CITY OF TACOMA
Tacoma Venues & Events

ADDENDUM NO. 1

Request for Bids Specification No. PF20-0334F

Tacoma Dome Fencing Project

Tacoma Dome Fencing Project Map v01-26-21

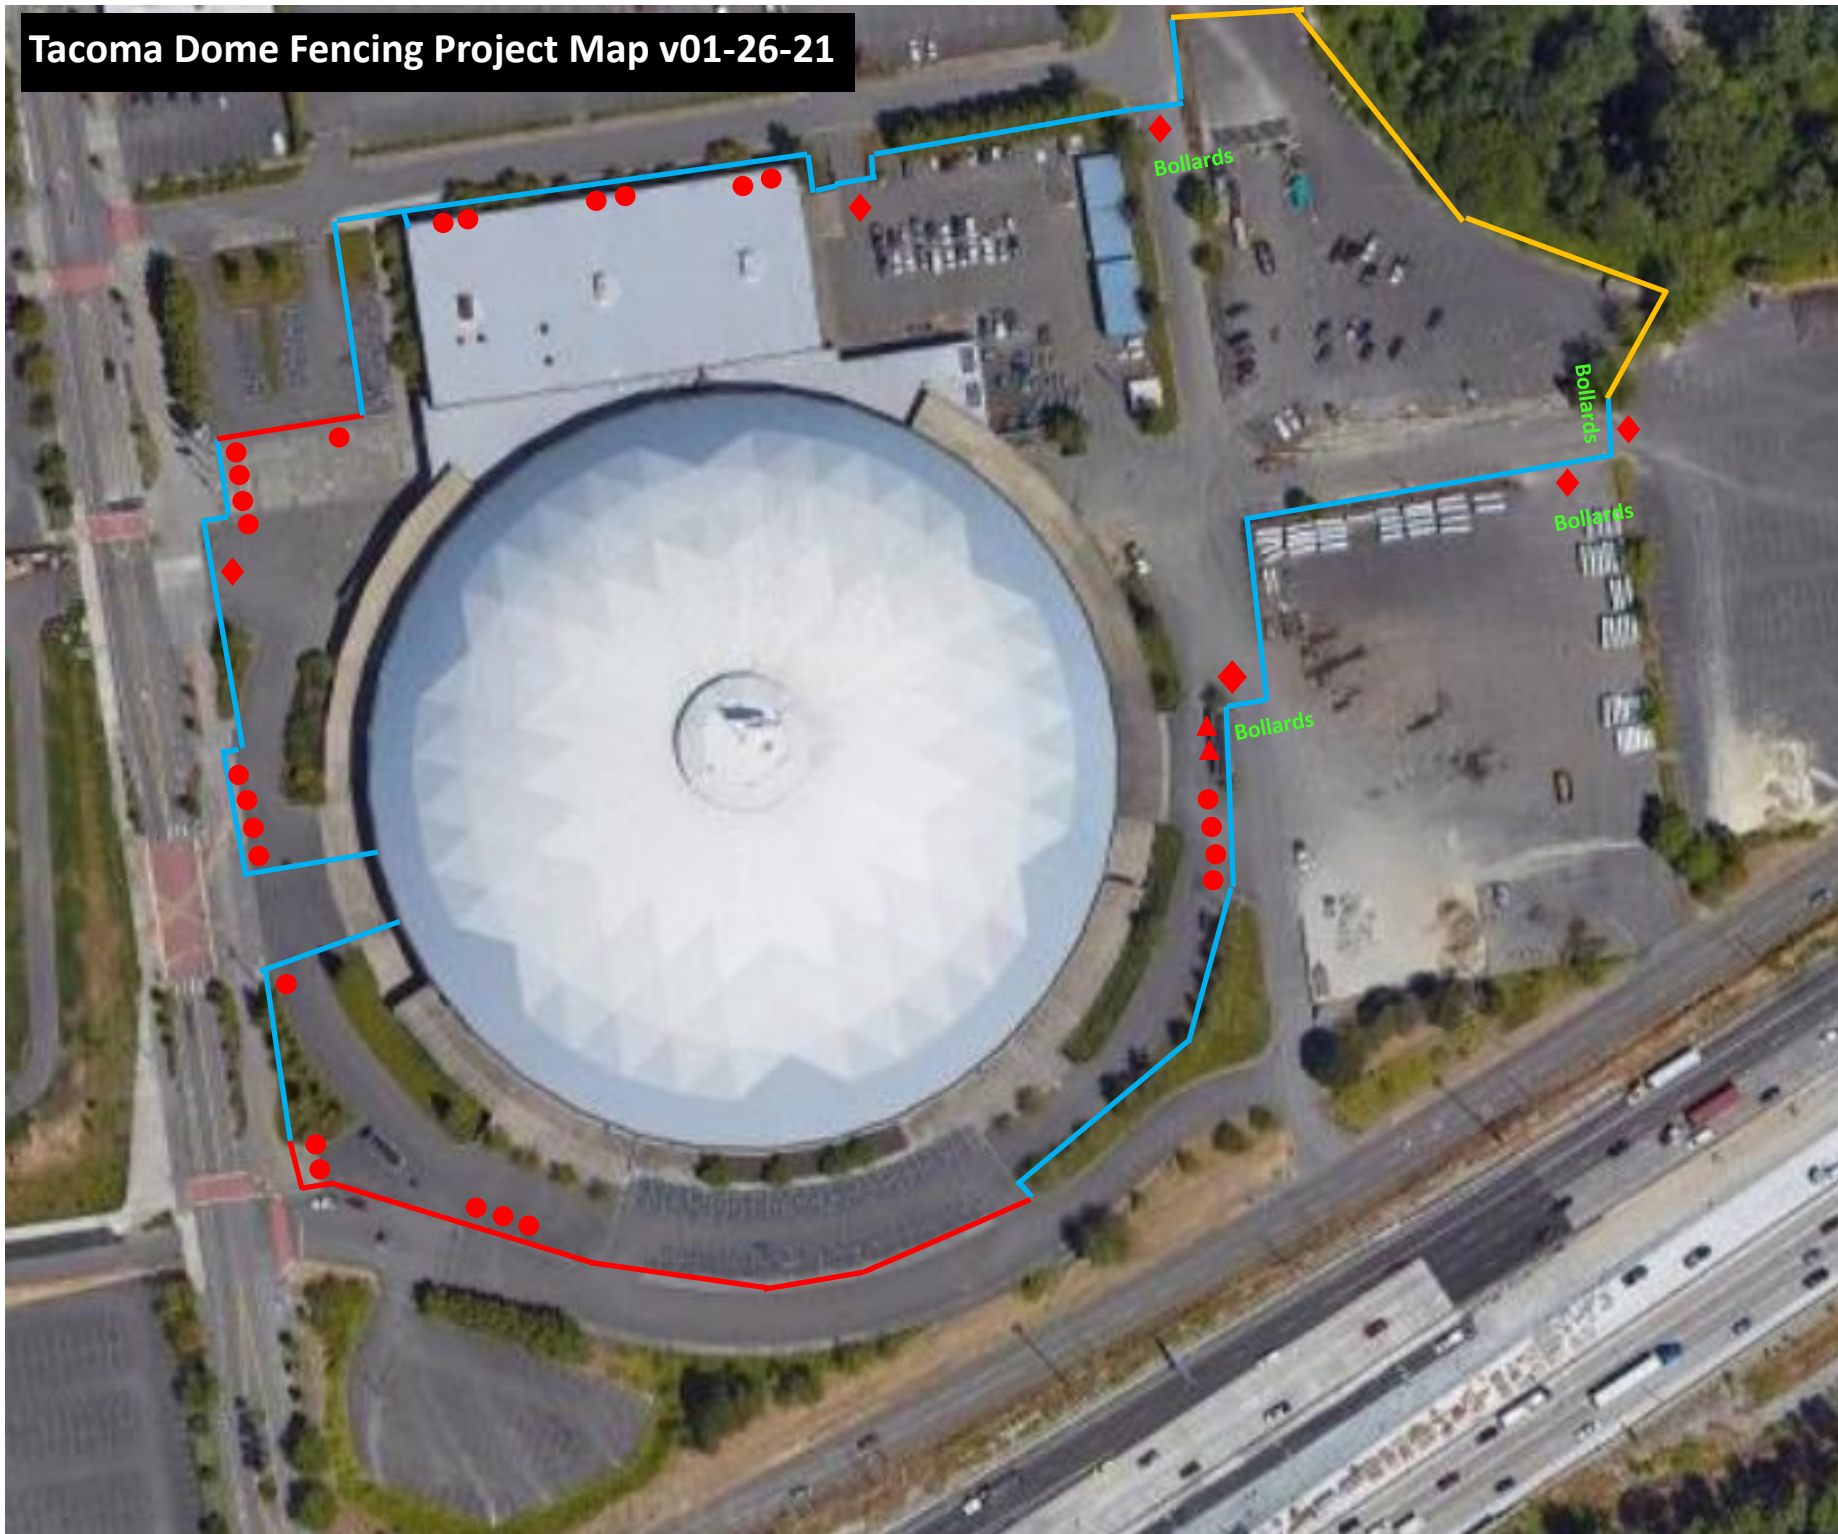
REVISIONS TO MAP PAGE:

The map page is replaced by the attached.

Question 1: I couldn't find a detail for what the fence will look like. Do you have a set of plans you can send over? - Can you confirm the attached fence style is what you would like the decorative/K4 fencing to match?

Answer 1: The entire fence except the chain-link needs to look the same in terms of style, regardless if it is the crash rated or ornamental. See the maps in Addendum No. 1 for the proposed fence line and additional details on the basic style of fence we are looking for.
